**TSG-RAN Meeting #23**  
**Phoenix, Arizona, USA, 10 - 13 March 2004**

**RP-040123**

**Title:** Clarification on reconfiguration of HSDPA Revision 11  
**Source:** Panasonic, Philips, Nokia

⌘ **25.214 CR 331** ⌘ rev **11** ⌘ Current version: **5.7.0** ⌘

**2. Timing diagram for possible DTX period of HS-DPCCH**

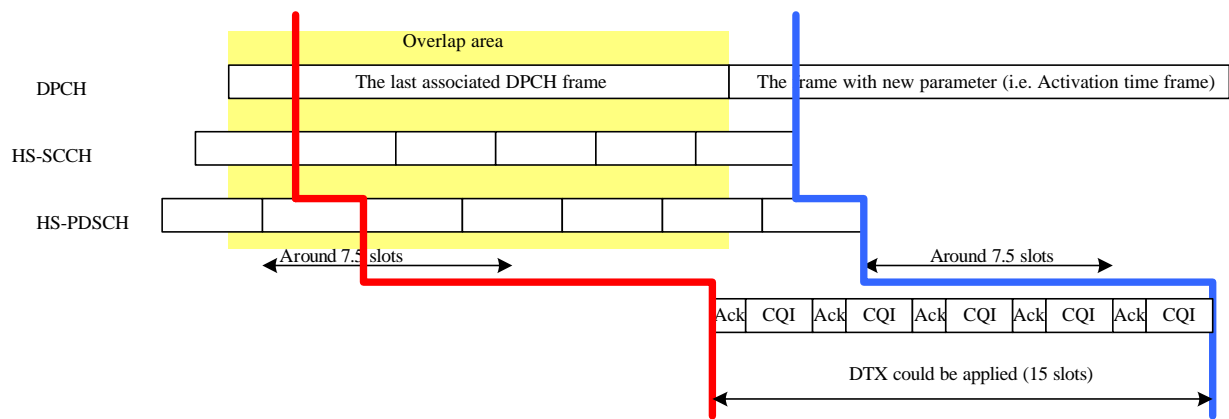
In following, timing diagram of how long DTX could be applied is shown. Red bold color line is the beginnig of the start of possible DTX period of HS-DPCCH. Blue bold color line is the beginning of the start of new parameter is applied according to TS25.331 specification section 8.6.3.1.

The UE should use DTX of HS-DPCCH in 5 subframe periods after the HS-DPCCH subframe boundary immediately before the HS-DPCCH subframe corresponding to the first HS-SCCH subframe which entirely falls within the last associated DPCH frame in which the pre-event parameters are applicable. If the UE does not use DTX in one or more of these fields of the HS-DPCCH, then in the fields in which DTX is not used the UE shall transmit ACK, NACK or CQI as described in sub-clauses 6A.1 and 6A.3.
